Staff Briefing Papers

Meeting Date	April 19, 2018	Agenda Item **5
Company	Dakota Electric Association	
Docket No.	E-111/M-17-821	
	In the Matter of a Dakota Electric Association Petition to Implement Tracker Recovery for Advanced Grid Infrastructure Investments	
Issues	Should the Commission approve Dakota Electric Association's request to implement a tracker for recovery of advanced grid infrastructure investments?	
Staff	Jason Bonnett jason.bonnett@state.mn.us	651-201-2235
	Eric Bartusch eric.bartusch@state.mn.us	651-201-2259
	Hanna Terwilliger hanna.terwilliger@state.mn.us	651-201-2243

Figure 3: Department's Proposed Rate Design⁸

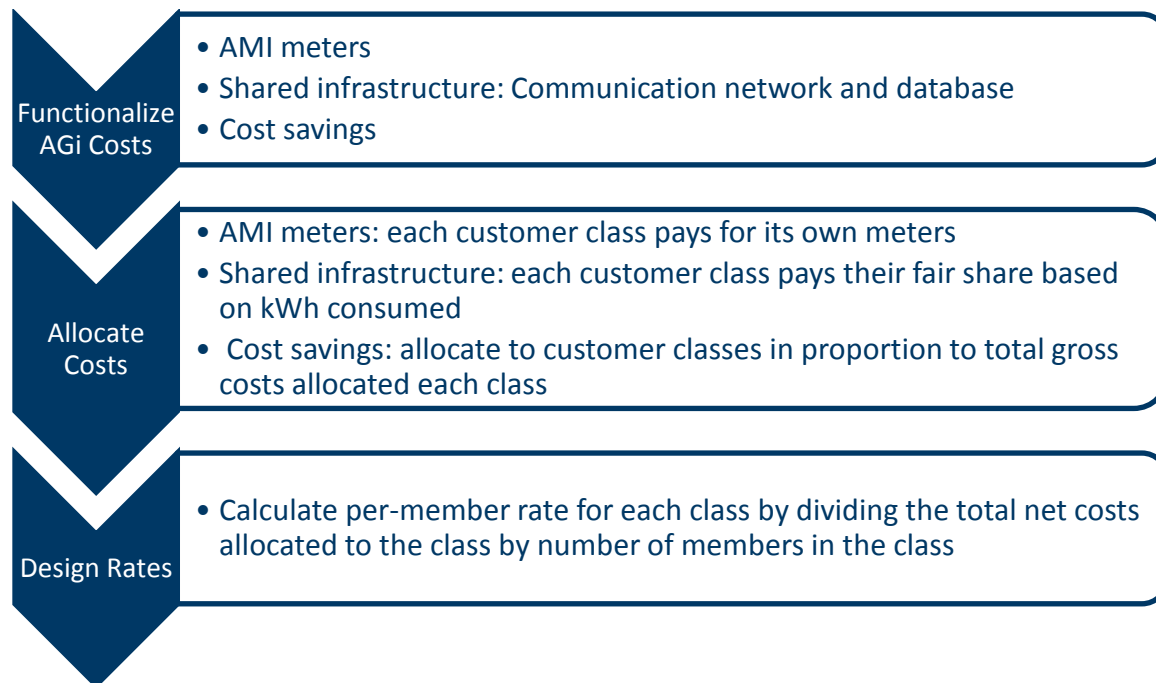
The Department recommended that AMI and MDM costs be recovered via a fixed charge rather than Dakota Electric's proposal to recover capital costs through a per-kWh charge. To estimate the fixed charge, the Department proposed using the following steps:

- First, group the AMI/MDM capital costs into three categories: AMI meters, shared infrastructure (communications network and any capital costs of the data system);

- Second, require each member class to pay for the costs of its own meters, under the principle that each member should pay for their own meter; and allocate the shared infrastructure costs among customer classes on a per-kWh basis, under the principle that members benefit from the communication and data system in accordance with how much energy they consume. After this gross sum is calculated for each class, allocate the reduction in base revenue requirements due to AMI/MDM (capital-cost savings associated with existing meters and operational-cost savings) proportionately to arrive at a net amount to recover from each member class. The total net amount to recover from each member class is thus the sum of their cost responsibility for the AMI and MDM costs, minus their share of the resulting cost savings, allocated on the same basis.

- Third, set the fixed charge for each member class by dividing the net costs allocated to the class by the number of members in the class.

The Department included the following figure to illustrate these steps.

In response, Dakota Electric agreed that the Department's proposed rate design resulted in fairer charges to its members. The Department's rate design approach spreads relative meter costs based on the cost of meters to each rate class and other common costs based on energy usage with total costs then collected through a monthly per meter charge.

In *Reply Comments*, Dakota Electric did recommend that capitalized project management cost be allocated in proportion to the allocation of shared-infrastructure costs, and provided rate design calculations assuming this modification.⁹
